ADDENDUM 2

CSP 22-68

Memorial Middle School Heating & Air Condition (HVAC) Improvements Funded through the Elementary & Secondary Emergency Relief (ESSER) Funds

April 8, 2022

1 LEVEL 1H MECHANICAL CHILLED WATER PLANT
 M3.13 1/4" = 1'-0"

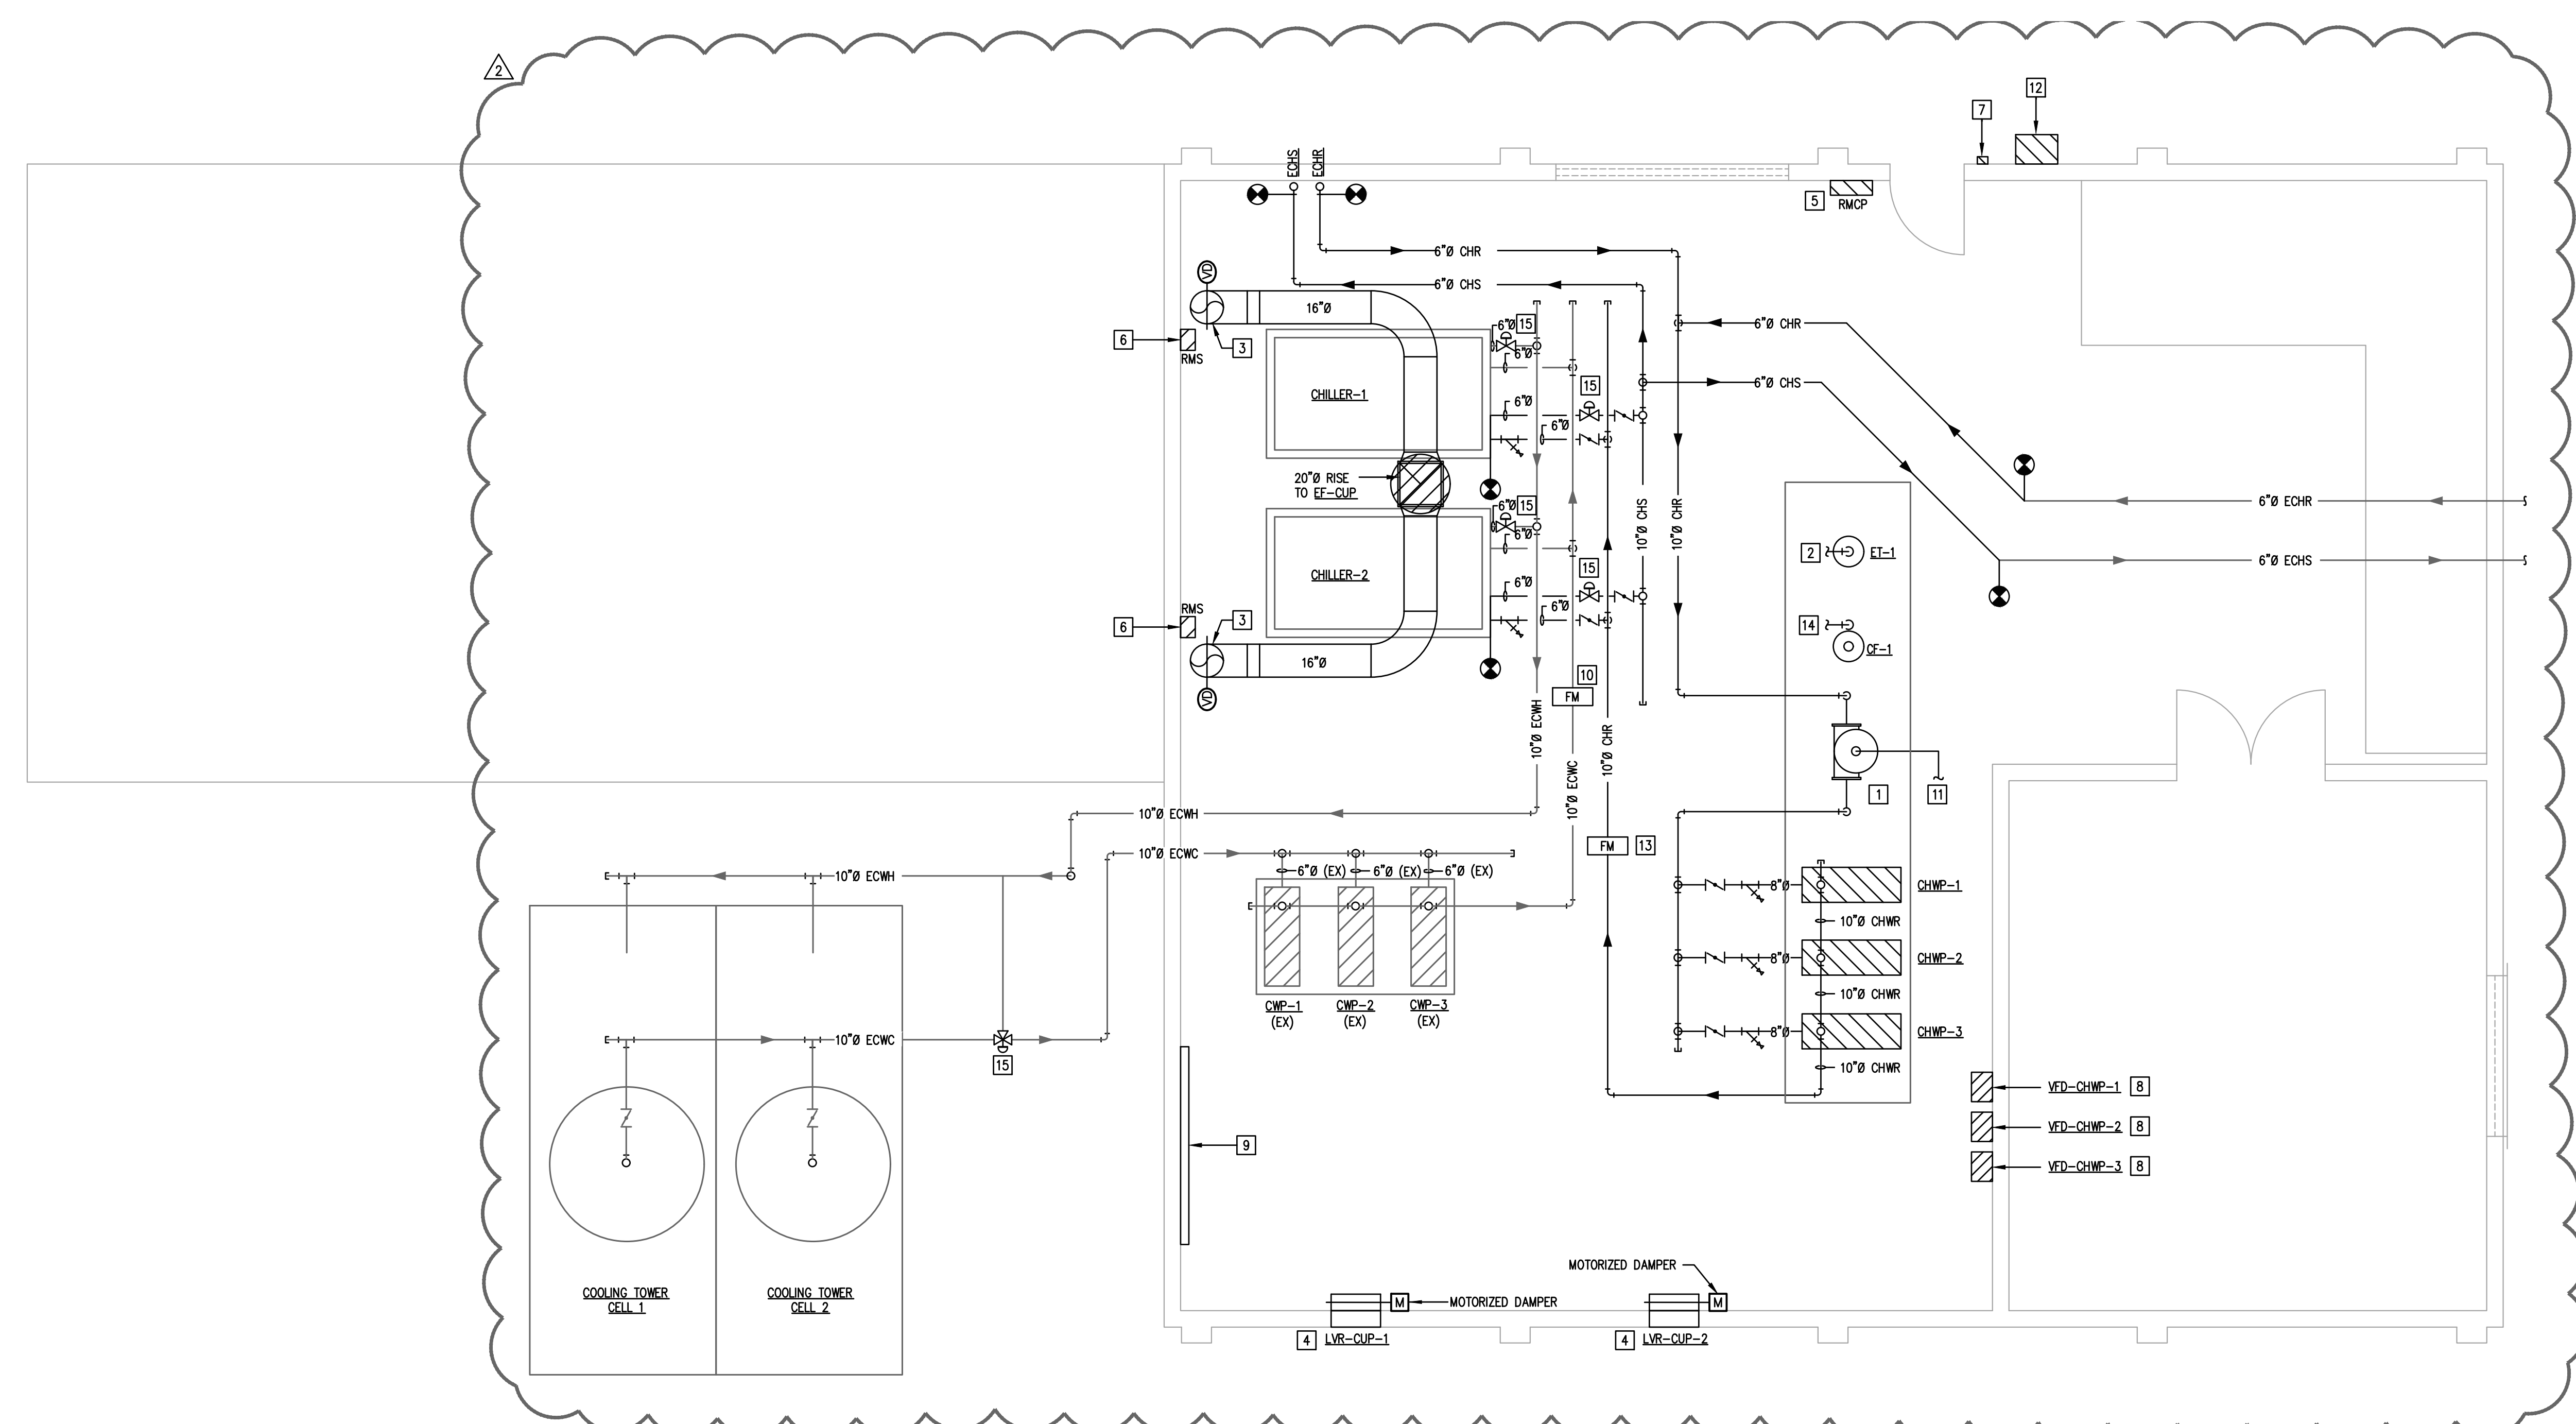
Item 14 SHEET M3.13 – ENLARGED MECHANICAL ROOM PLANS

A. Corrected title block.
B. Added control valves to condenser water at chillers.
C. Revised keyed note 9.

- THREE SOCK CHEMICAL FEEDER MOUNTED ON EXISTING HOUSE KEEPING PAD. REFER TO DETAIL 17/M6.01.
 - NEW MOTORIZED CONTROL VALVE EQUAL TO BRAY SERIES 70.
